City of Baker School Board
Board Meeting Agenda
Tuesday, June 4, 2024, 6:00 P.M.
School Board Office

**City of Baker School Board Meeting
May 7, 2024**

To: Manning Architects **DATE:** 4/25/2024
FROM: Jason Catlin **QUOTE #:** 077
PROJECT: Baker High School Renovations and Additions
DESCRIPTION OF CHANGES: RFI 160 & 191 Cost for Mods of Ductwork to Fit in Ceiling Space & Added Smoke Damper

CHANGE ORDER INFORMATION:
Change Order Number: 008
Date: 5/30/2024

SECTOR B - NORTH CAFETERIA EXTERIOR ELEVATION
2/A201 3/32" = 1'-0"

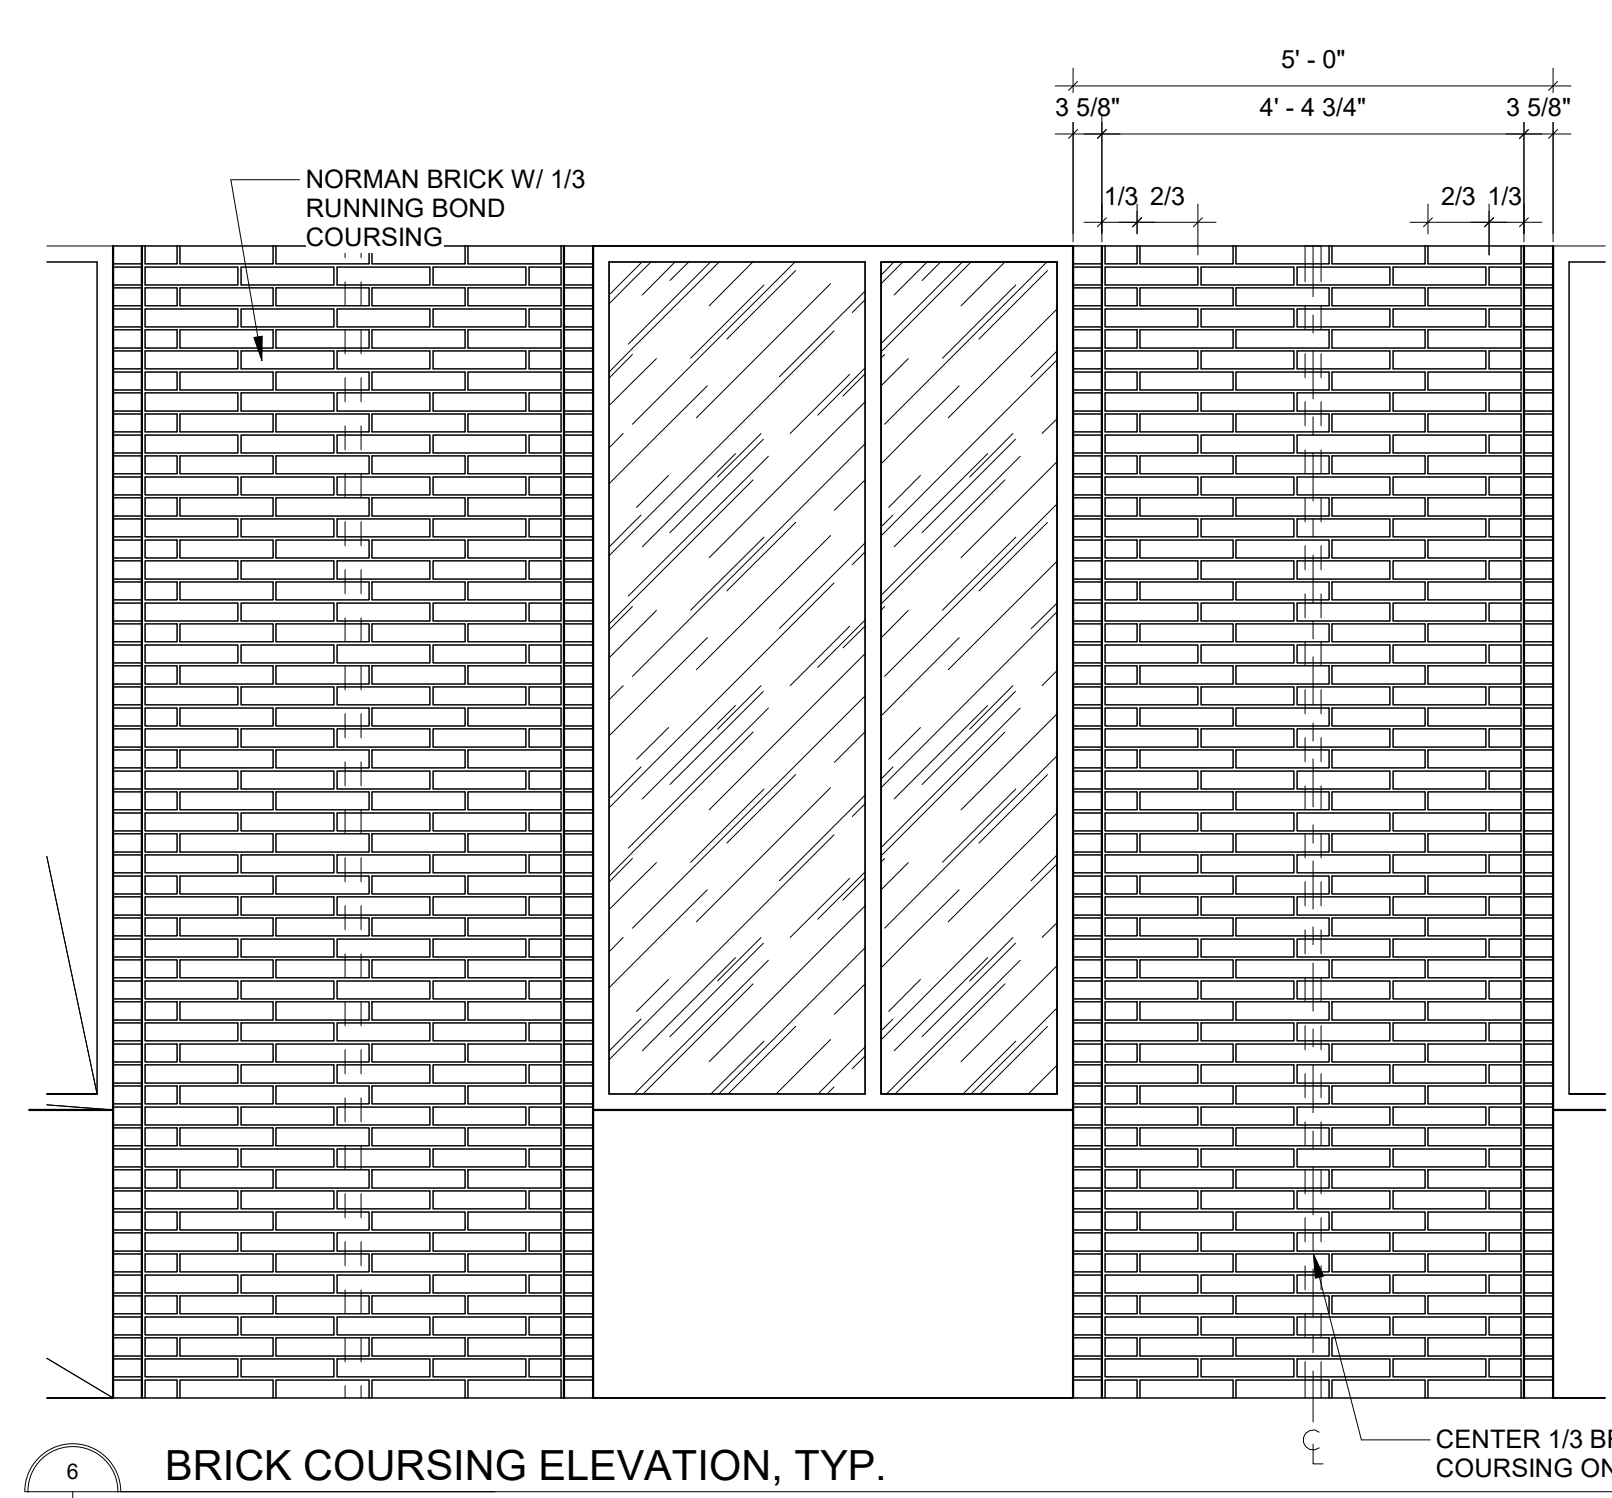
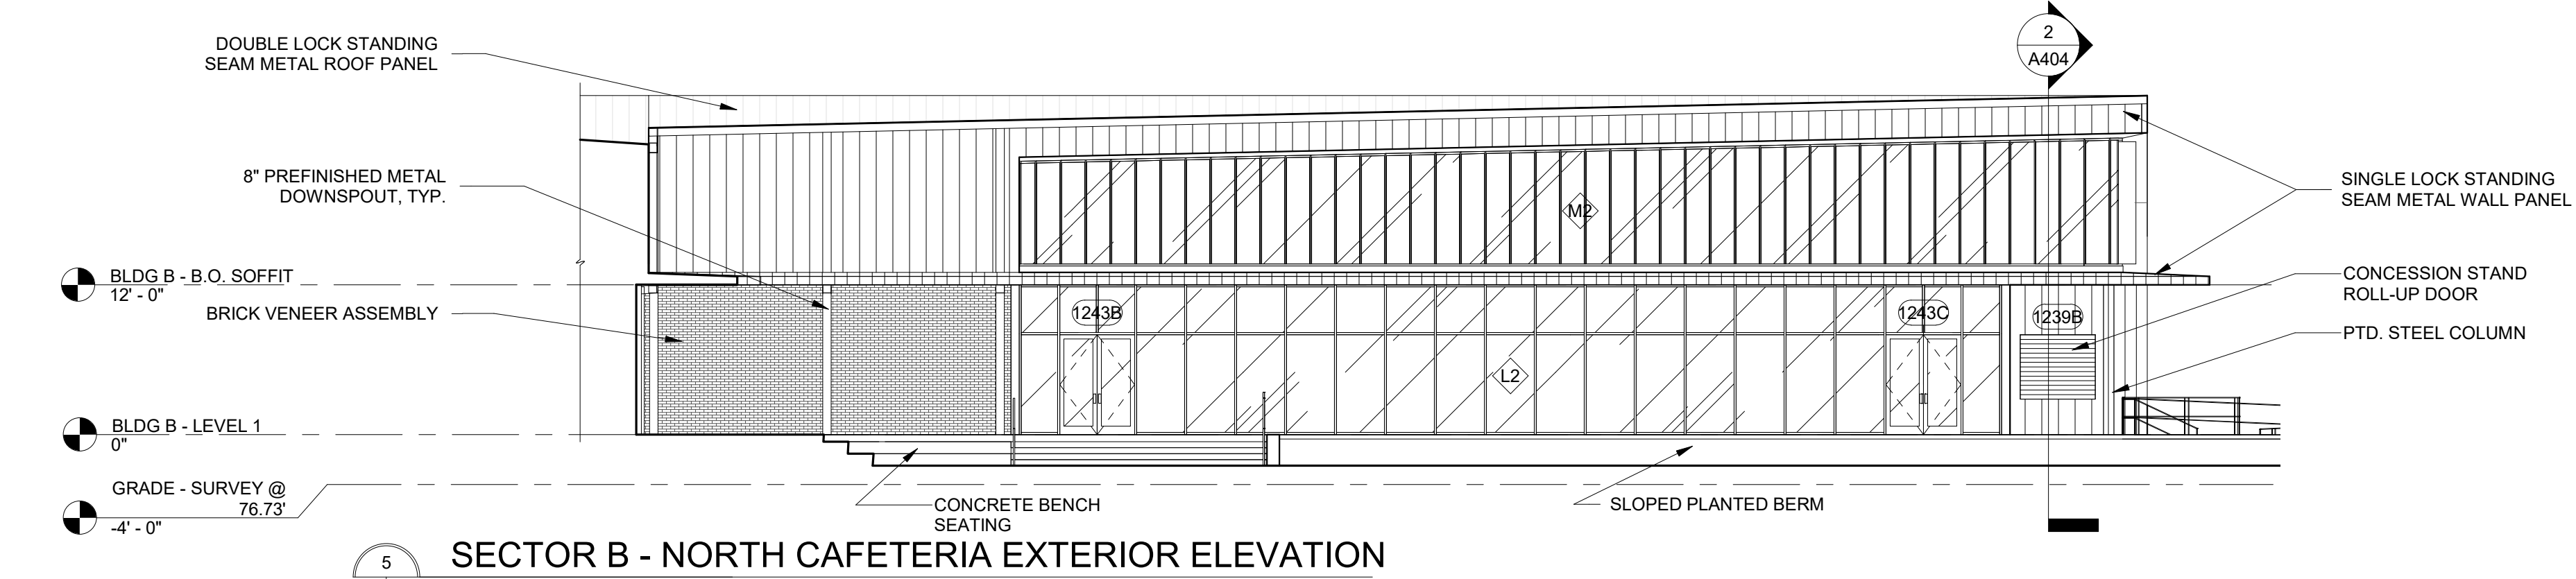
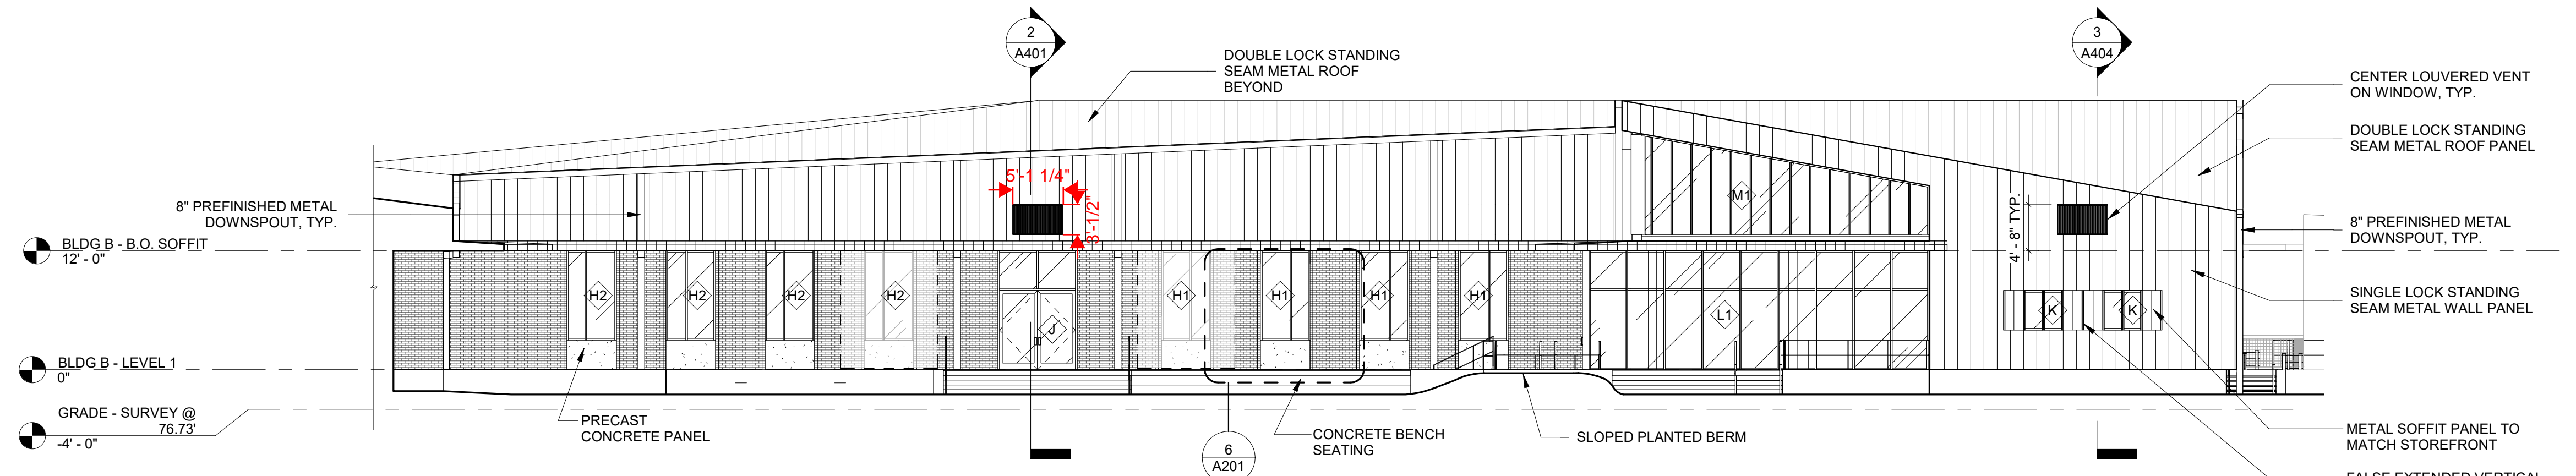
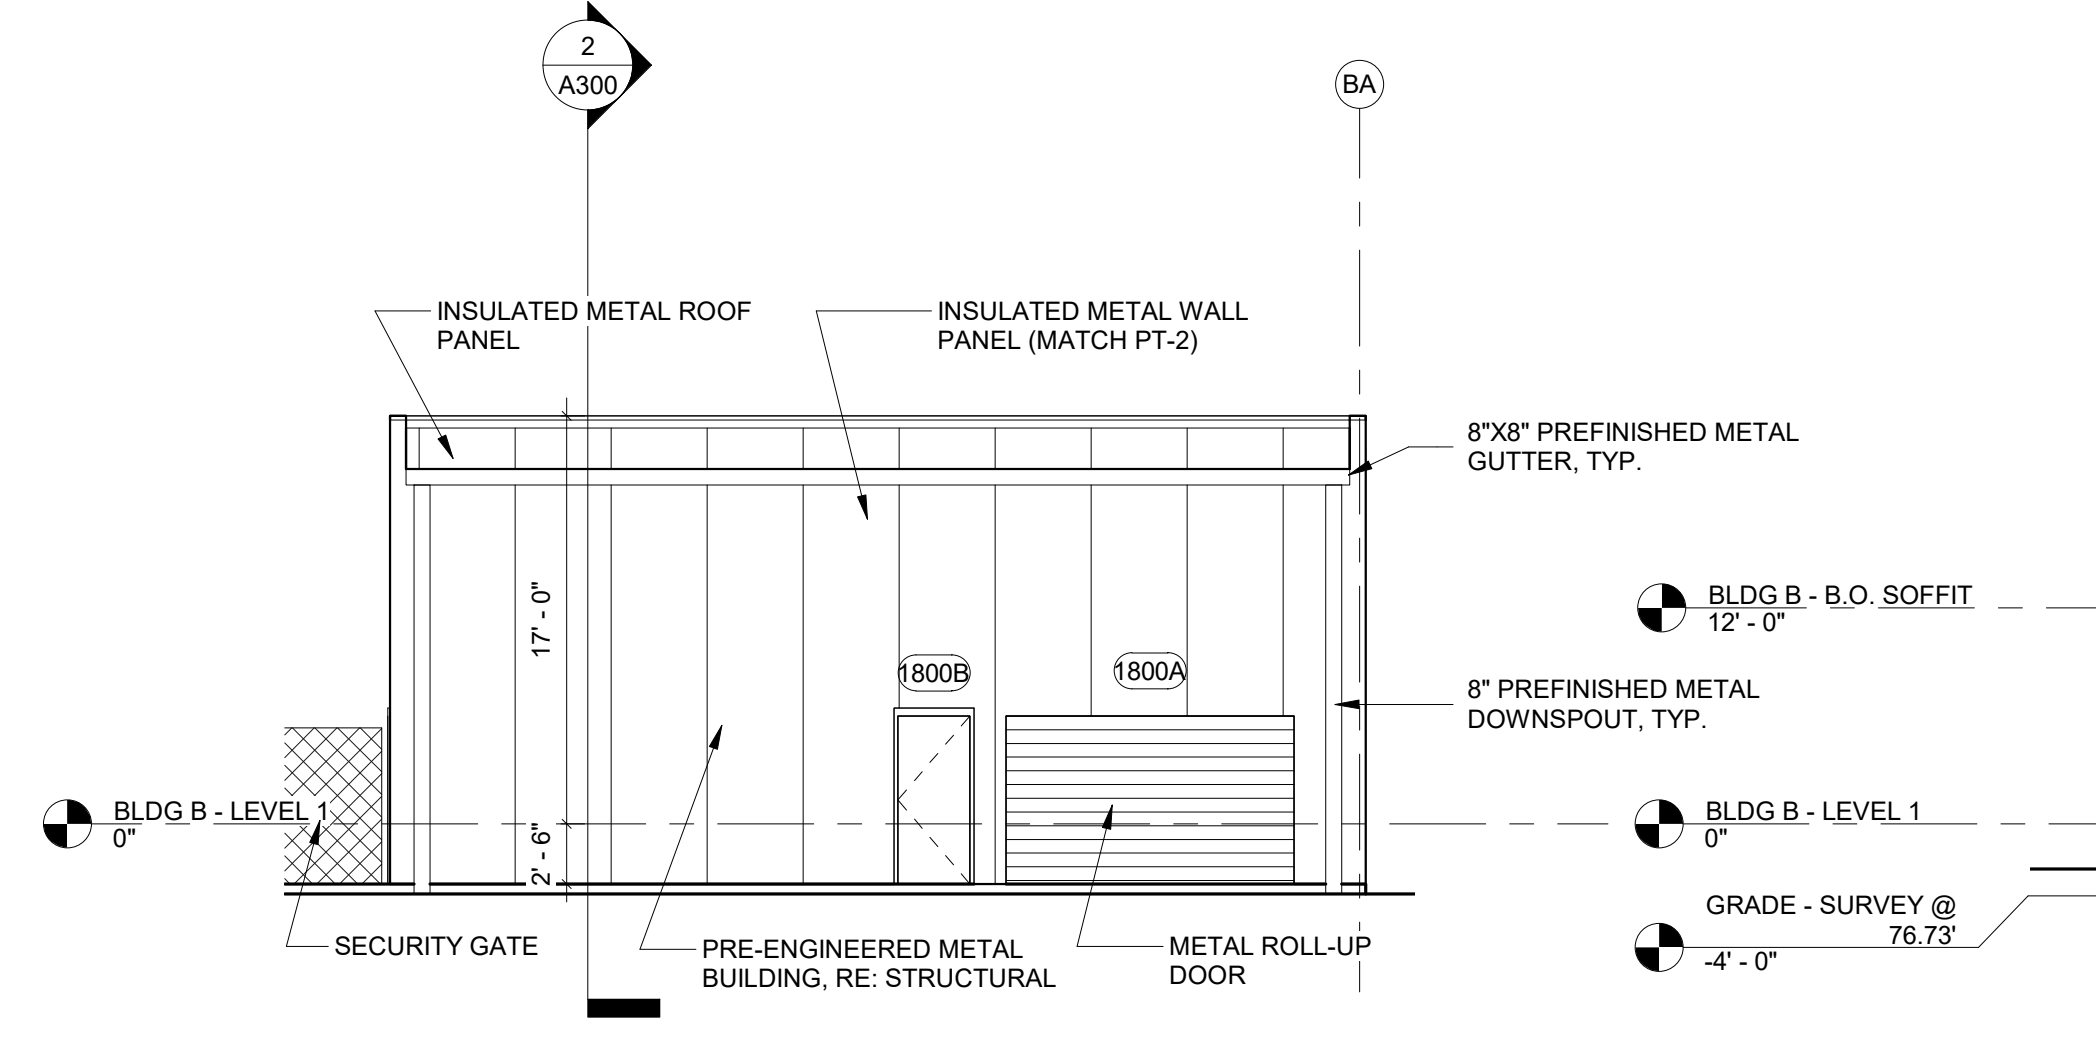
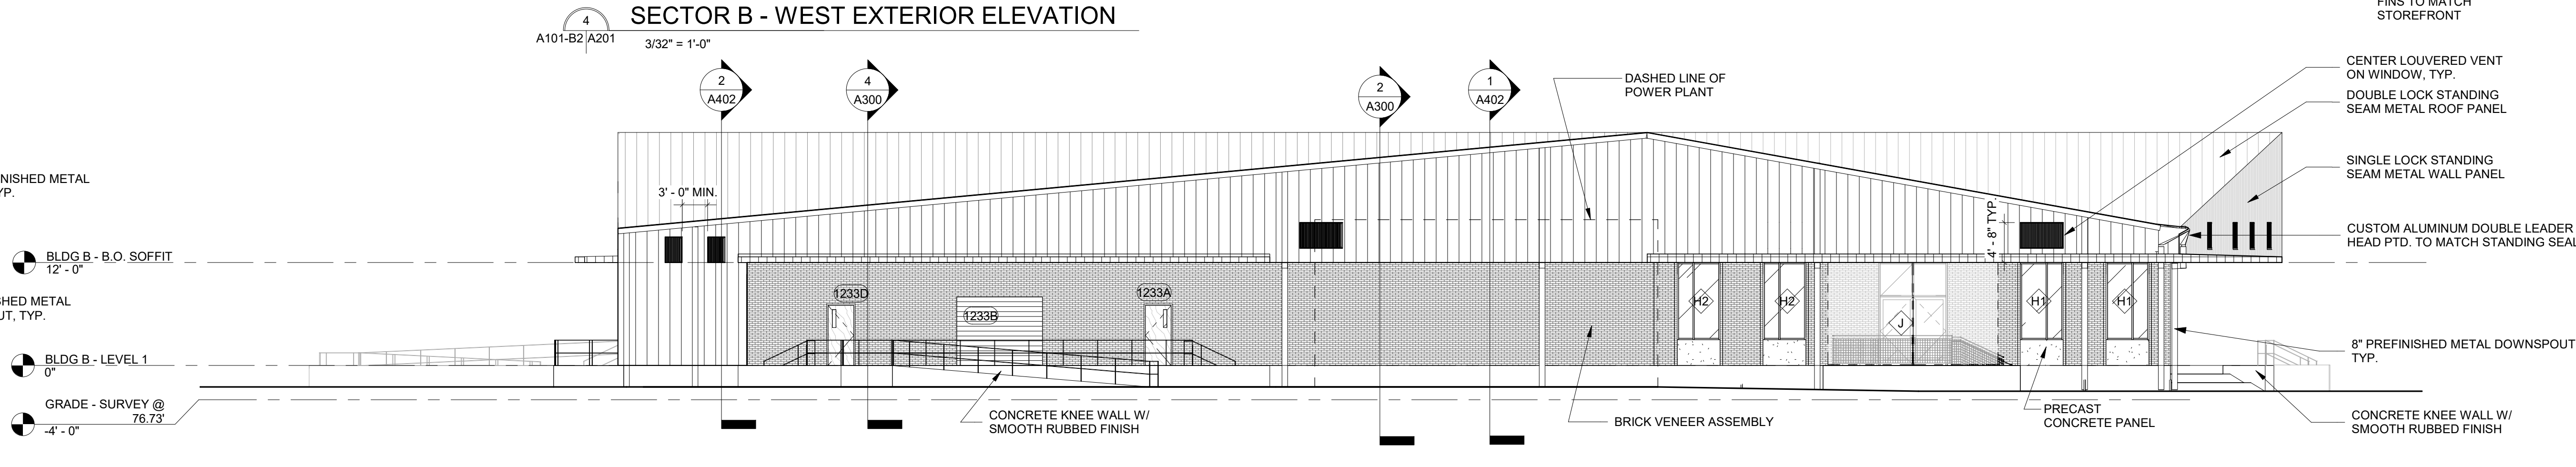
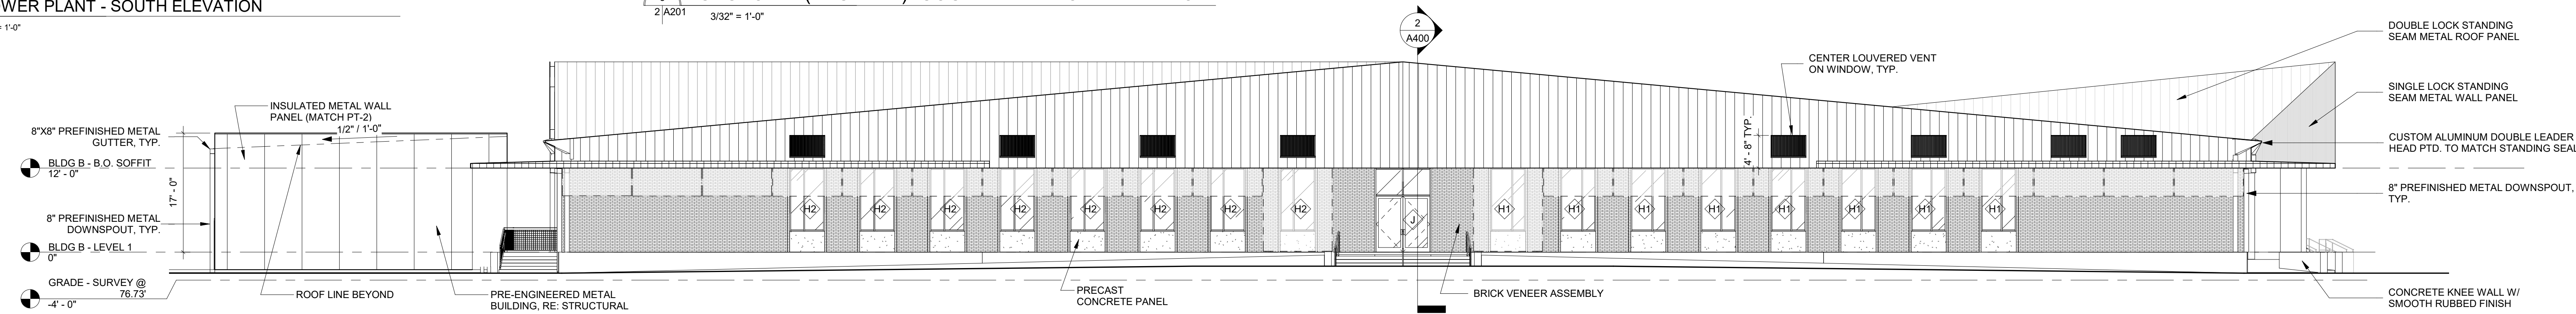
Provide scope of screens wanted on North/Groom Elevation so pricing can be completed.

Official Response: Ryan Bertucci (**Manning Architecture Interiors Planning**) responded on Thursday, April 25th, 2024 at 5:18PM CDT
 Advise if this is within the revised allowed provided by CSRS.
